RAPID UPDATE

Rapid Update 653

Granturismo – front hood striker bolt check

DATE: AUGUST 1 2023

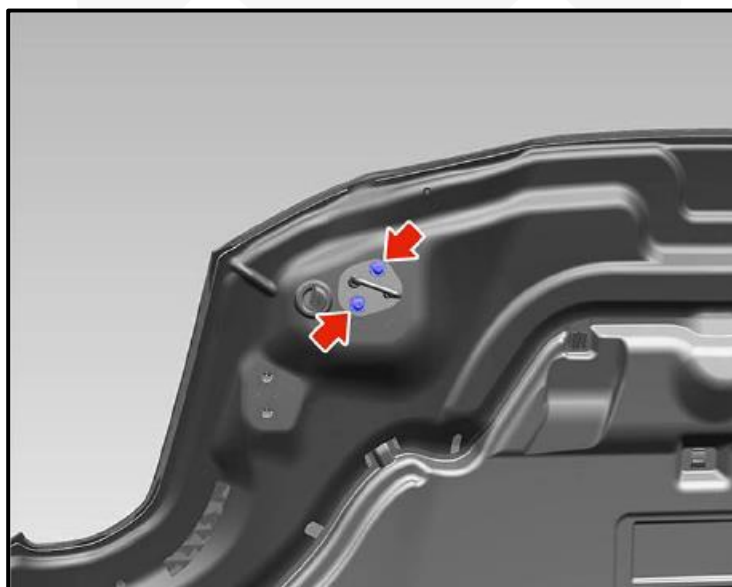
Certain Maserati GranTurismo (189) MY24 listed in MODISCS+ are involved in a Rapid Update to carry out a procedure for checking the fasteners of both front hood strikers.

This action is necessary because, on a single case found at the Plant, only one fastener has been found with a lower torque per the data. This concern does not lead to a potential unexpected hood opening and no parts were found disconnected. The only potential consequence is related to some rattling noises due to the vibration. The procedure consists of a simple check with a torque wrench and possible torque tightening of the incorrect tightening. The expectation, however, it's not to find any vehicle with this concern.

1. Always check ModisCS+ to see if the vehicle is involved in this action and if it has not been previously performed.
2. Open the front hood and locate both hood strikers, located on both the front right and front left sides of the front hood.
3. **Use a torque wrench** to torque the two fasteners on each striker to **8 (eight) Nm**.

TORQUE SPECIFICATIONS	
Right Front Striker Fasteners	8 Nm (5.9 ft-lb)
Left Front Striker Fasteners	8 Nm (5.9 ft-lb)

4. Carry out the procedure for all 4 Hood striker fasteners.
5. The procedure is completed.
